24 February 2010

SUBJECT: "CORDOVA PROVIDER" ABSID 8127054
Tacoma Boat Building Co. Hull 425
218.5' x 60.0' x 12.0'
Oil Spill Response Vessel / Deck Cargo Barge (U.S. ON 639268)
Stability Review on behalf of the U.S.C.G. – NVIC 3-97

STABILITY LETTER

Barge "CORDOVA PROVIDER"
FIGURE 1

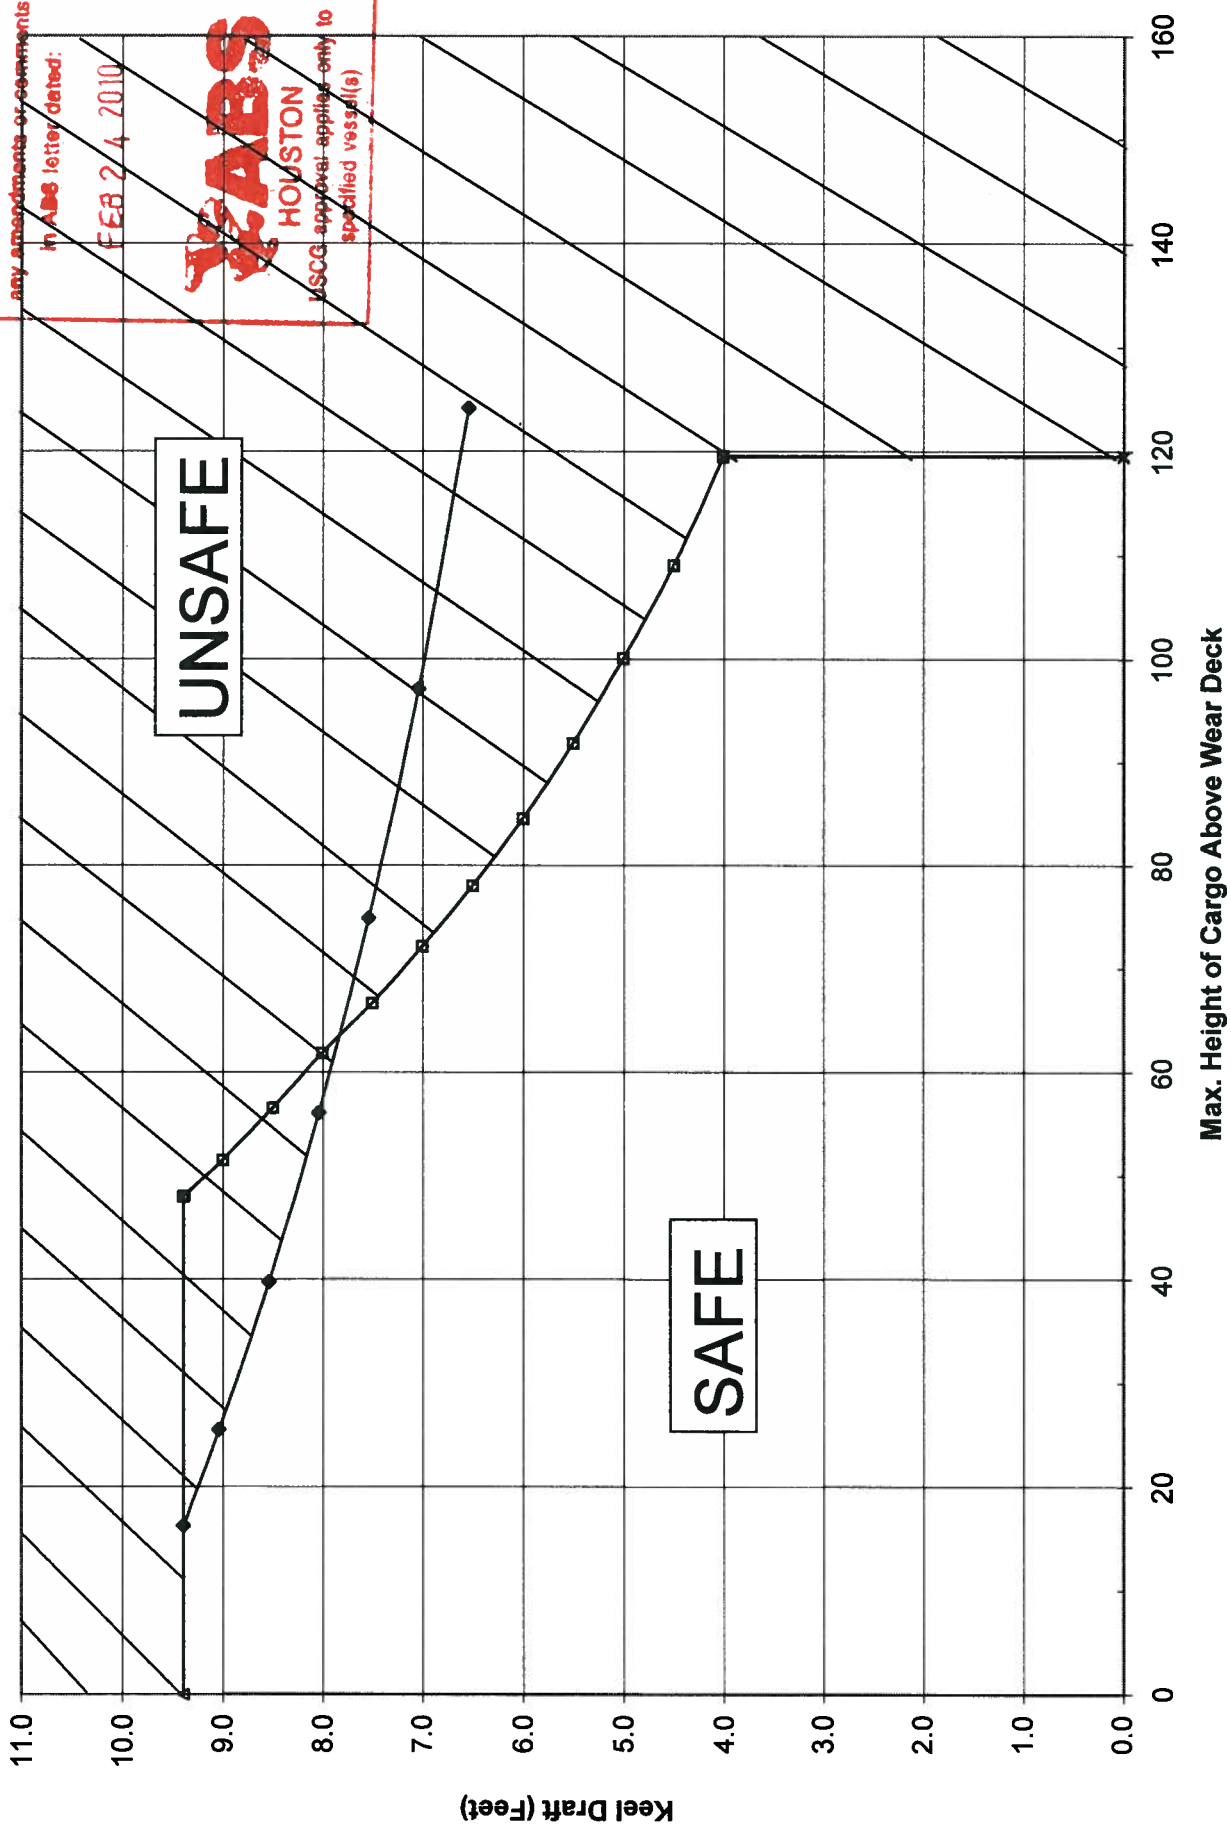
The carriage of deck cargo shall be in accordance with the attached cargo loading diagrams, bearing the ABS Americas approval stamp dated 24 February 2010. Deck cargo may be positively secured against shifting.

- Attachments:
- a) Maximum Deck Cargo Height vs. Draft Diagram, bearing the ABS Americas approval stamp dated 24 February 2010.
 - b) Maximum Deck Cargo VCG vs. Draft Diagram, bearing the ABS Americas approval stamp dated 24 February 2010.
